Project Name: Edendale Crossing

Description: Preliminary site plan approval recommendation and rezoning approval recommendation

RE: Edendale Crossing- Preliminary Site Plan Review – 3rd Review

**Preliminary Site Plan / Site Condominium / Planned Development Review
for
White Lake Charter Township, Michigan**

PSP-1

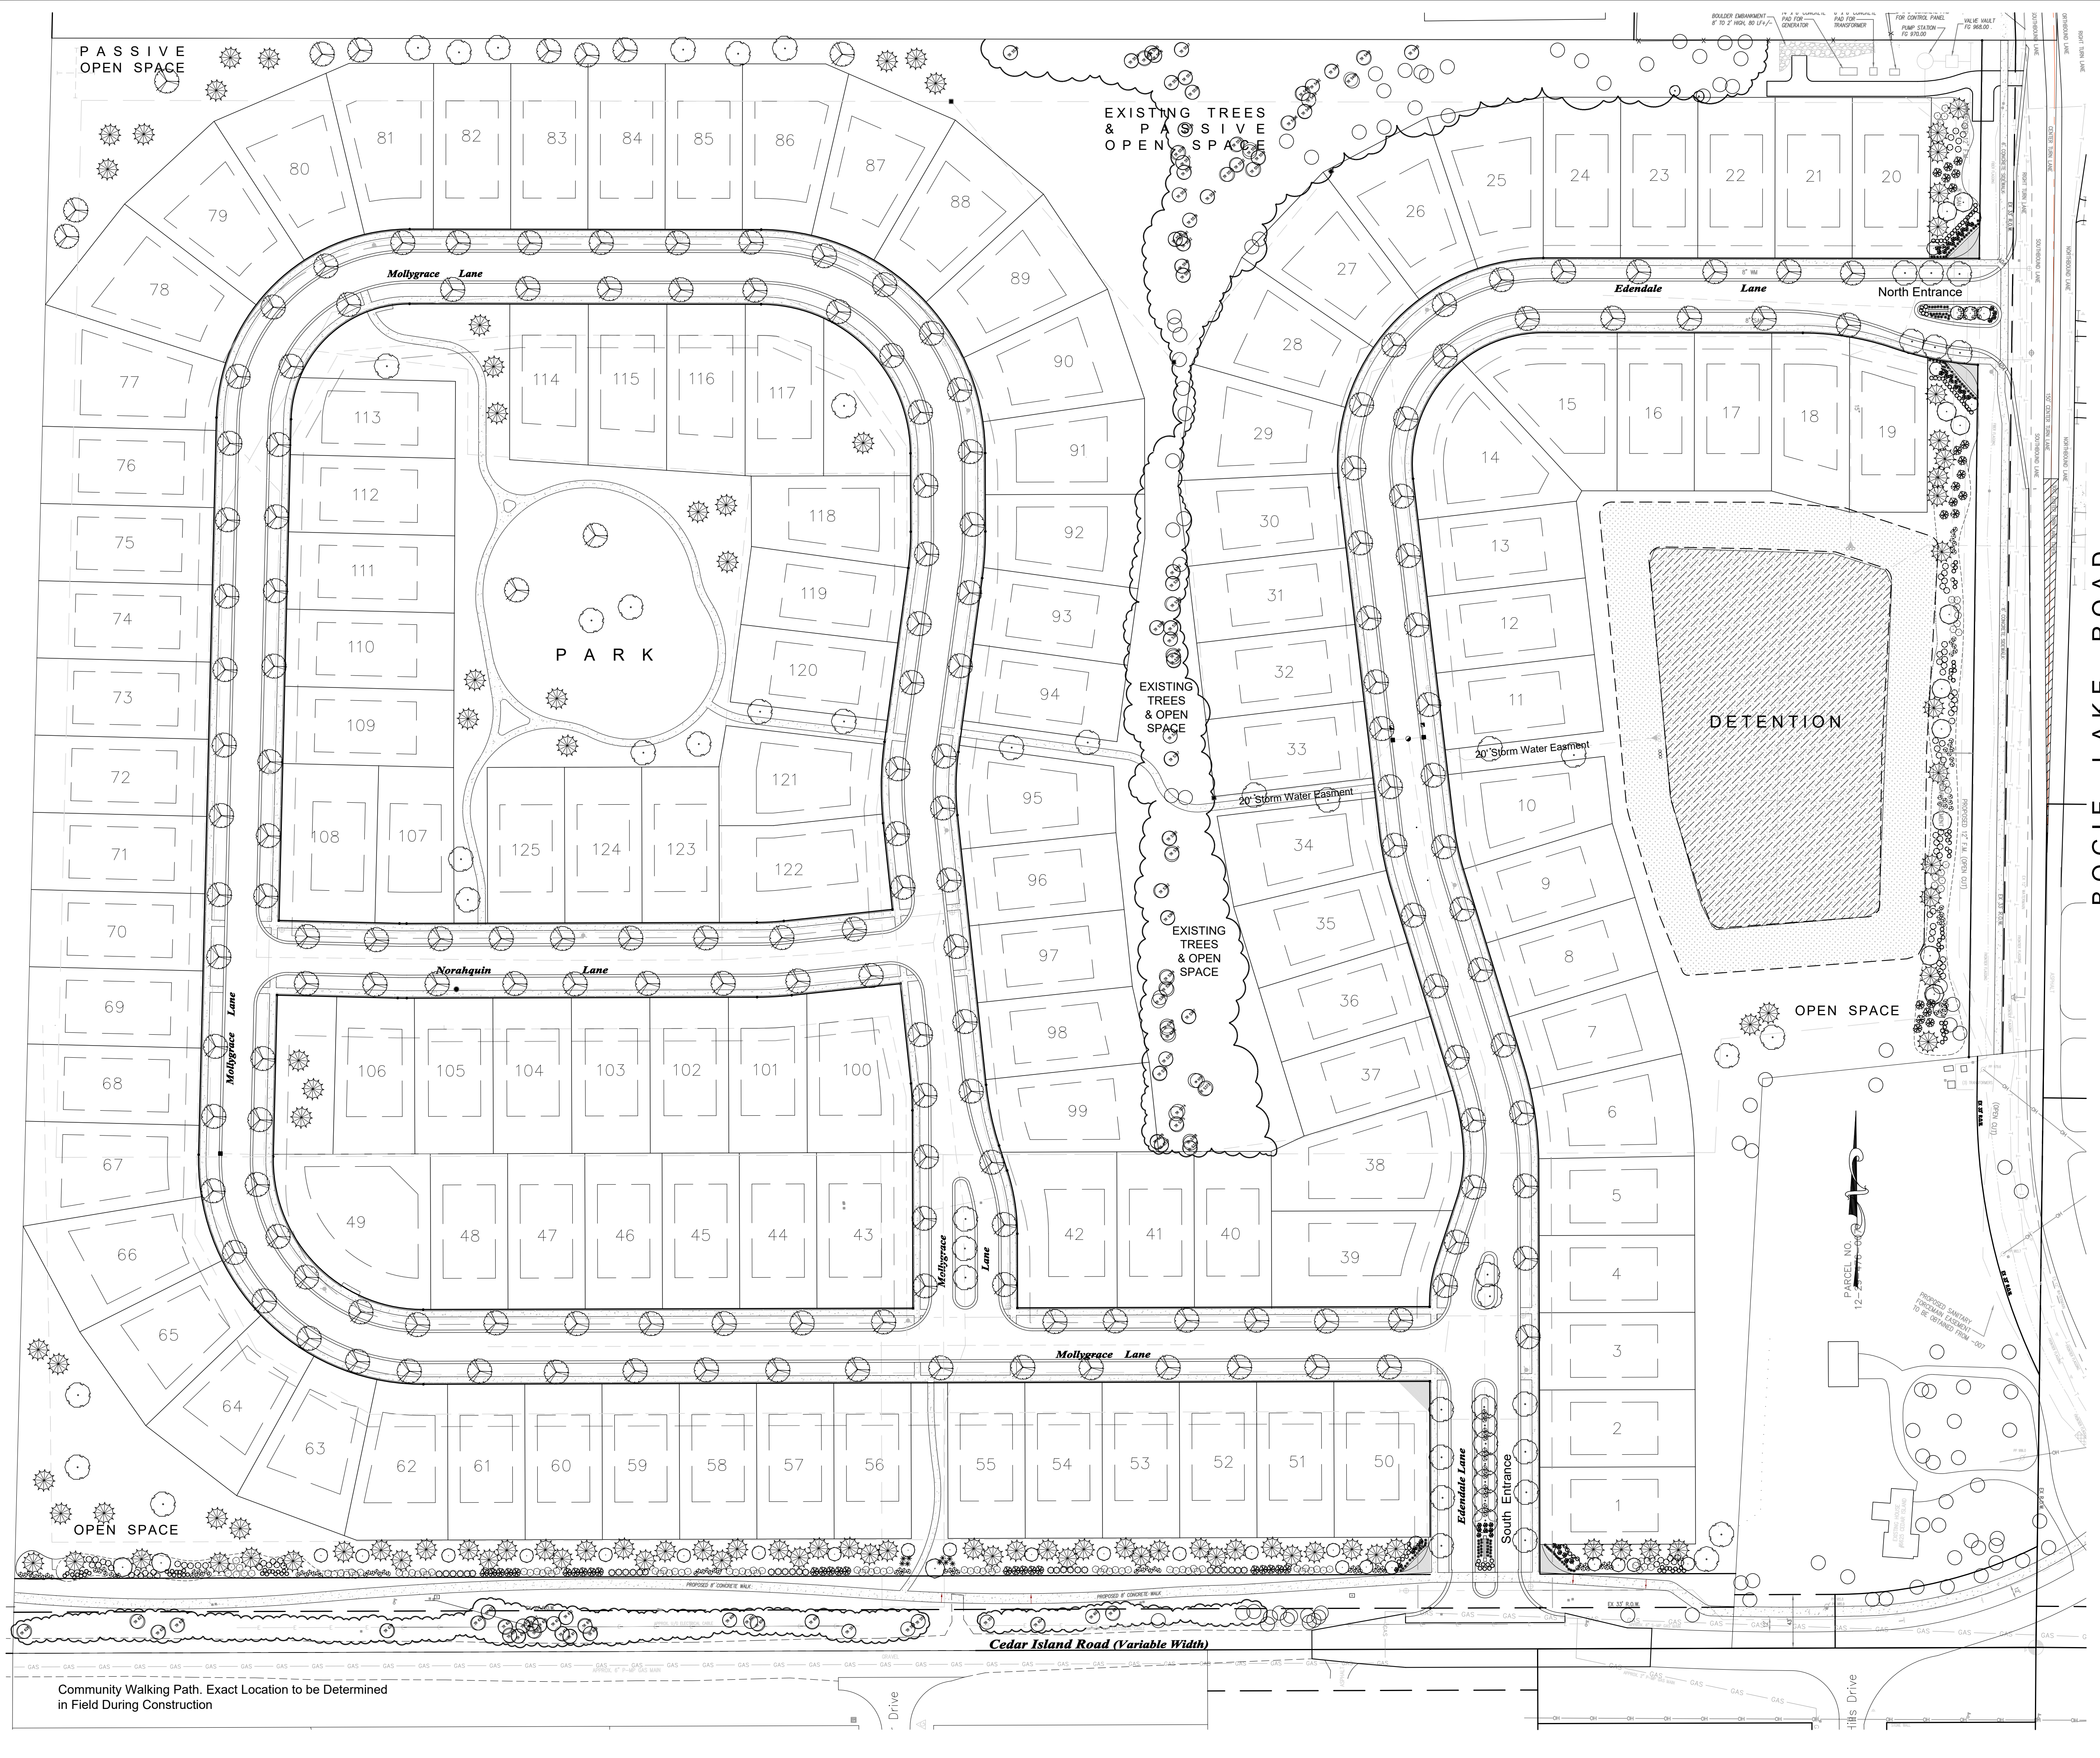
1. Plan by J. Eppink Partners, Inc. dated September 19, 2025- Sheet PSP-1- Site Data- Table- Parcel size is incorrect. Correct acreage is 45.47. This is also incorrect in the same table in the Proposed Density calculations as well as the Existing AG& R1-A Zoning Parallel Plan(Sheet PSP-2). **Comment outstanding.**
2. Sheet 19-Cedar Island & White Lake Middle School Sidewalk Plan- Remove 'Proposed Pedestrian School Crossing' note to the west of Carla Hills Drive as this was where the safety path was previously proposed.
